Site name: Portal Cons Pacific Park Bridge Rd, North Wrexham		Units/ plots checked: Full footprint (excluding office) Unit 1	
Postcode: LL13 9PN			
Installers Name [REDACTED]			
Date: 10/06/2022			
Inspection by: [REDACTED]		Weather: 15°C Fine

Site name: Portal Cons Pacific Park Bridge Rd, North Wrexham		Units/ plots checked: Full footprint Unit 2	
Postcode: LL13 9PN			
Installers Name: [REDACTED]			
Date: 10/06/2022			
Inspection by: [REDACTED]		Weather: 15°C Fine

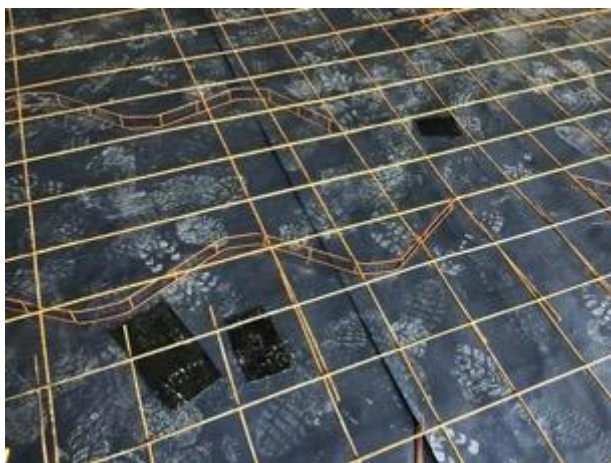
Damages caused by driving on the membrane

Lorry reversing on the membrane

Tool thrown and damaged membrane

Tool dropped and damaged membrane

Patch repairs made following damage by steel mesh

Photo 10/06/2022

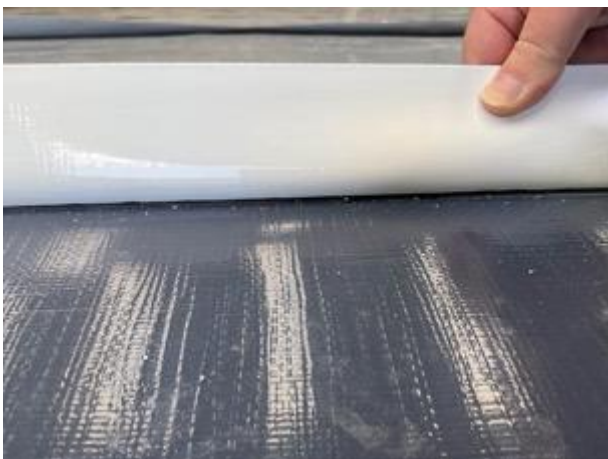
1) install membrane to 4m x 2m area where steel reinforcement has been stored and provide photographic evidence that this has been done
